Shearwater Perdix 2 and Petrel 3 Firmware Release Notes

VERSION 91 2022-06-01

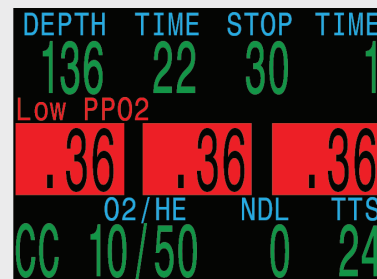
Vibrating alarms have been added.

The vibrations will occur every 10 seconds while a Warning, Error, or Alert message is actively displayed along the bottom row of the display. Once the message is cleared by a button press the vibrations will cease, even if the underlying condition remains. Low and High PPO2 alarms from externally monitored PPO2 (CCR) are an exception to this rule (see below). Vibrations can be completely disabled.

Vibrating alarms have been added whenever an Alert, Warning, or Error is being displayed

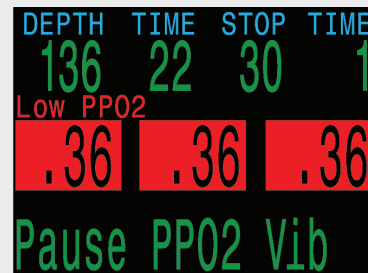
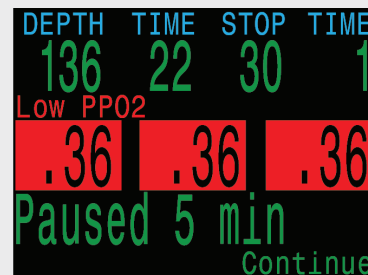
Continuous vibrating alarms for externally monitored (CCR) low and high PPO2 have been added.

Due to the critical importance of PPO2 levels in a closed-circuit rebreather, externally monitored PPO2 alarms will continue to vibrate every 10 seconds, even after the message has been acknowledged, as long as the alarm condition remains.

When a Low or High external PPO2 alarm exists, the vibrating alarm will continue even after the Warning message has been cleared.

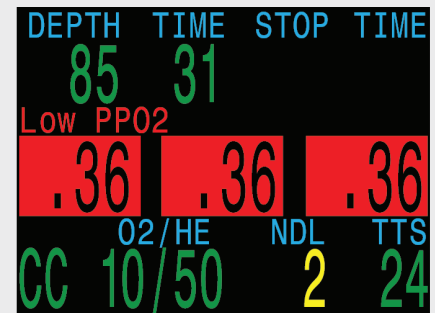
A "Pause PPO2 Vib." Menu option will be available while a PPO2 vibrating alarm condition is active. This will pause PPO2 vibrating alarms for five (5) minutes. During this time other warning conditions will still cause vibrations.

While such vibrations are active, a menu option will be available to Pause PPO2 Vibrations

This will pause vibrations for 5 minutes

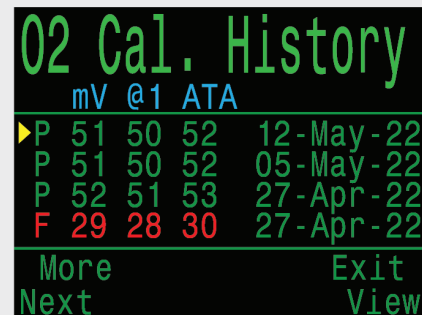
Support for Petrel 3 hardware with a 2.6" AMOLED display.

The default color for the AMOLED display is green. White cannot be chosen as an option for the Main color

The AMOLED on the Petrel 3 features bright vibrant colors and a larger 2.6" size

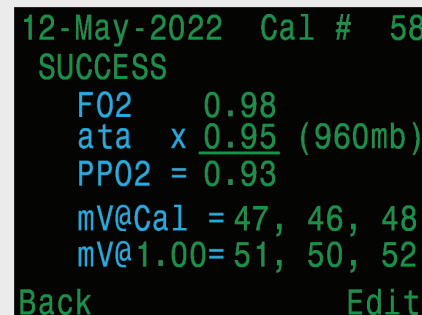
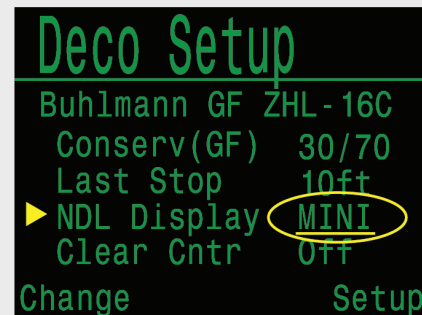
Displays a history of PPO2 calibrations. A log browser shows the date, status, millivolt (mV) levels, and input parameters for all PPO2 calibrations.

A history of PPO2 calibration results can be viewed

Details of each calibration can be viewed

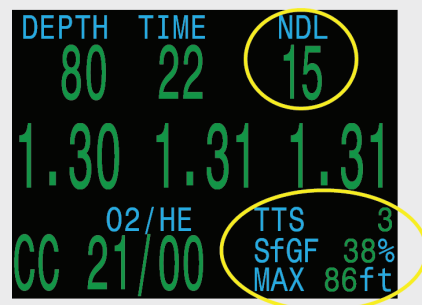
The “NDL Display” setting can be set to “Mini”. The Mini display can be configured to show 2 custom values, in addition to TTS which is fixed. The main display is slightly changed, with NDL moving up to the top right where DECO STOP is normally shown. NDL will show here until deco stops are needed, at which time it will change automatically to show deco stops.

A MINI display be chosen as the NDL Display setting

This option will move NDL up to the DECO STOP area. Once deco stops are needed they will replace the NDL.

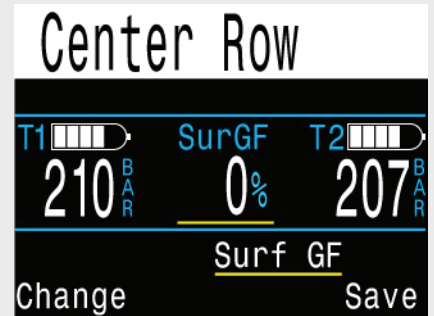
Configurable Mini displays have been added. These allow up to 3 displays to be shown in the area normally used for 1 display, although at a smaller font size.

Two Mini display sets can be configured. The set configurations are separate for the tec modes (OC Tec, CC/BO) and the rec modes (Air, Nitrox, 3 GasNx).

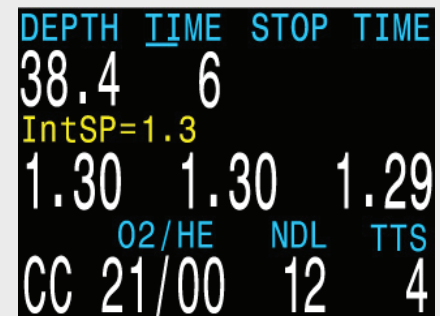
Bailout CCR PPO2 monitoring option added. When the Dive Mode is CC/BO, the PPO2 Mode can be set to “BO CCR” (other options are “Int” and “Ext”).

The BO CCR option is a combination of Int and Ext.

- The external PPO2 cell measurements are displayed in the center row.
- However, the internal PPO2 setpoint is used for decompression and CNS calculations.

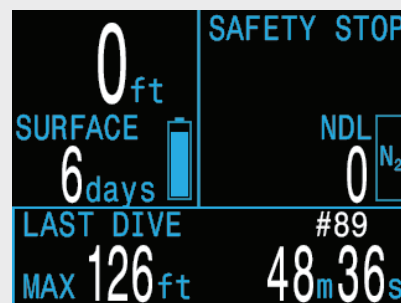
Added user configurable “Alerts”. These can be programmed to provide a warning when specified limit is reached. Also, the applicable display on the main screen will change to yellow while limit is exceeded. On the Peregrine, the vibration will activate with the warning.

The “Vibration” setting is only available on the Peregrine. Other models are visual alerts only.

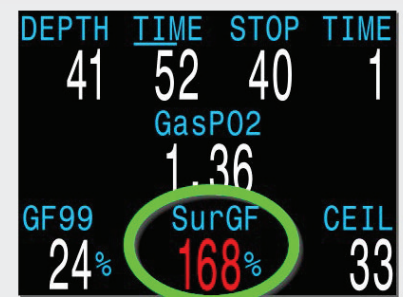
Surface GF display added. This shows the gradient factor if you were to surface immediately. This is different from GF99, which shows your gradient factor at the current depth. Is available:

Surface GF is the gradient factor if you were to instantly ascend to the surface

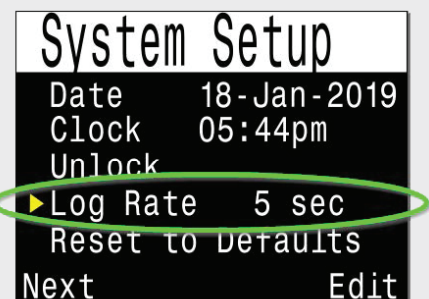
Log sampling rate can be set to 2, 5, or 10 seconds (previously always 10 seconds). Note that log downloads may take longer with faster sampling rates as more data is being recorded. Also, less logs can be stored until they are overwritten. For example, about 1000 hours are stored at a 10 second rate, but only 200 hours at a 2 second rate.

Log Rate can be set to 2, 5, or 10 seconds

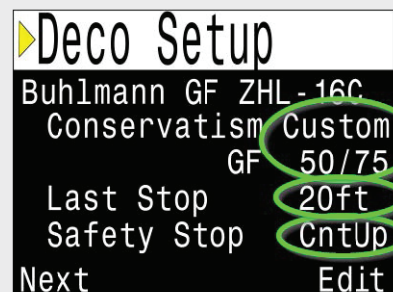
Allows user to select a 20ft/6m last stop depth in OC Rec mode. Previously the last stop was always 10ft/3m in OC Rec mode.

New OC Rec Deco Options

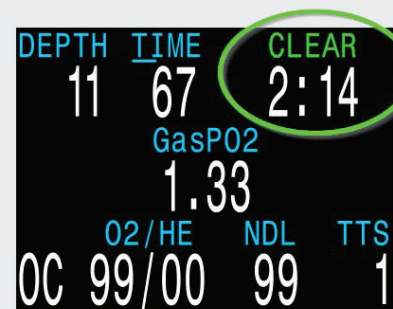
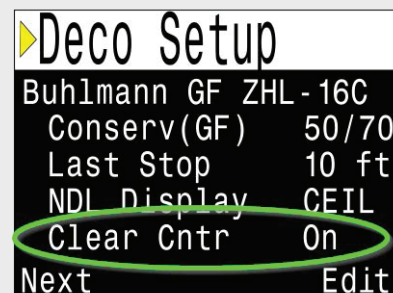
A “Deco Clear” up-counter option has been added.

The “Clear Counter” counts up once deco is clear

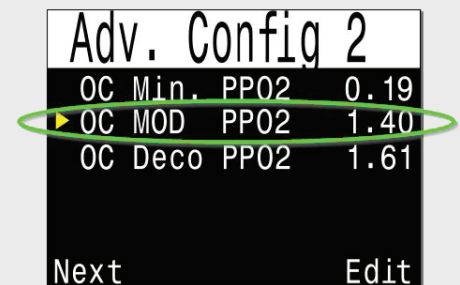
The PPO2 limit options have been changed for OC Tec mode.

The “OC Max PPO2” has now been removed and replaced with a “OC MOD PPO2” setting. The MOD setting only applies to the bottom depth phase. The dive computer automatically switches to using the “OC Deco PPO2” limit when within 2 stops of the next deco stop. The “OC Deco PPO2” limit also sets where predictive deco gas switches occur. Also, if the current gas has greater than or equal to 80% oxygen fraction, then the deco limit is used, as the gas is assumed to be a deco gas.

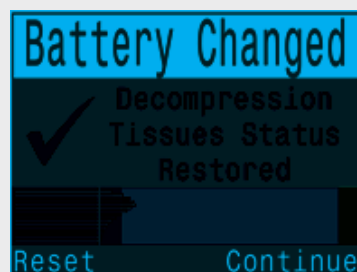
CHANGE Compass mark heading menu moved to reduce button presses. Also, the compass can now be viewed while marking. Operation: when viewing compass a left button press brings up an "Exit/Mark" menu. Right press marks compass, Left press exits to main screen. Previously had to navigate to regular menus to mark the compass.

The mark heading command now requires less button presses

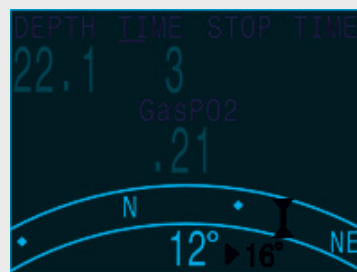
IMPROVE When a heading is marked, the display now shows the offset angle between the current heading and the marked heading. This is useful for navigating patterns. For example, a box pattern requires turns at 90° intervals, while a triangle pattern requires turns at 120° intervals.

The offset between current and marked heading is now shown (in this example 16°)

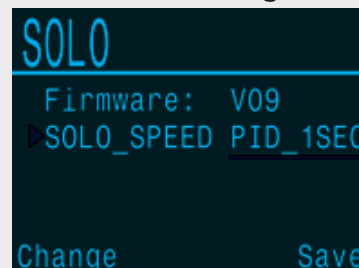
NEW Added support for changing settings on peripheral boards.

For example, on the SOLO board (solenoid and oxygen controller) the Solenoid Speed setting can be adjusted. Go to “Bus Devices” page on Petrel to access peripheral boards. Settings viewed here are stored on the peripheral device.

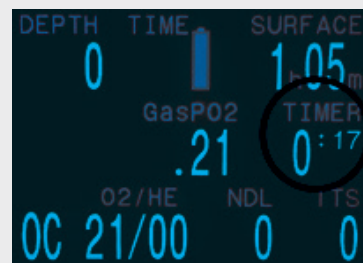
The current compass numerical value (azimuth) is shown on the “Mark Heading” menu.
